**Final Opinion on
Payment for Provision of Flexible Ramping**

**James Bushnell, Member
Scott M. Harvey, Member
Steven Stoft, Member
Benjamin F. Hobbs, Chairman
Market Surveillance Committee of the California ISO**

August 16, 2011

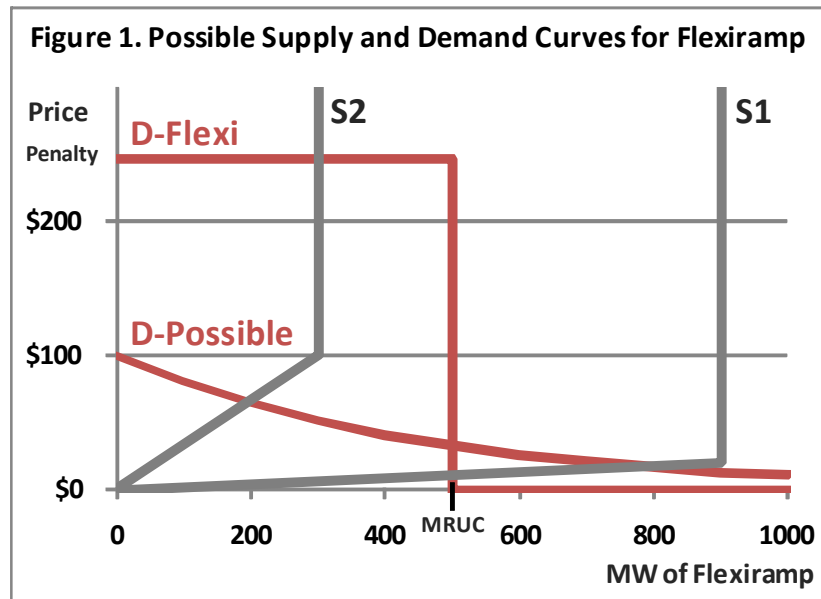
The RTPD's process for acquiring flexiramp can be viewed as an interplay of a demand curve for flexiramp with supply. In particular, the MRUC requirement in combination with the penalty price on the flexiramp constraint defines the ISO's demand curve (shown as D-Flexi in Figure 1) for the flexiramp product.

The higher, step-function demand curve, labeled D-Flexi is the demand curve determined by the flexiramp proposal, although MRUC will vary from hour to hour. The lower, smooth demand curve, labeled D-Possible, is one possibility for what an optimal demand curve might look like. (It is possible, of course, that the optimal curve might be higher than D-Flexi for some values of flexiramp to the left of 500 MW; we do not mean to prejudge the marginal value of flexiramp.) In one respect, D-Possible is more reflective of the value of flexiramp than D-Flexi because it is smooth. It is unrealistic to think that MRUC could be worth \$247/MWh (its penalty price) when 499 MW is available and \$0/MWh when 501 MW is available. Such an on-off demand curves makes sense when complying with a black-and-white regulatory requirement, such as NERC’s requirement for operating reserves, but they make little sense (except as operational compromises) when they are meant to reflect the value of a physical hedge against random contingencies. The penalty level of the D-Flexi demand curve is also unlikely to reflect the economic value of flexiramp since it was determined with little regard for the value of flexiramp.

Fortunately, based on reports of the ISO’s market simulations of flexiramp, the supply curve for flexiramp seems to be frequently most similar to S1. In other words, flexiramp is anticipated to be usually very inexpensive. In this case the D-Flexi curve will demand too little, but will pay a lower price, often zero, for a fairly generous supply of flexiramp. However if the system runs into conditions under which flexiramp is not cheap, perhaps as shown by supply curve S2, then using the wrong demand curve will likely cause significant over procurement at an uneconomic cost. Since the ISO’s reported simulations indicate that a generous supply of flexiramp is currently available, we do not recommend a change in the current design. However, for the ISO’s Renewable Integration Market & Product Review, Phase 2 (“Renewable Integration Review”), we suggest that the demand side of the market be seriously considered in a manner consistent with scarcity pricing for other market products.
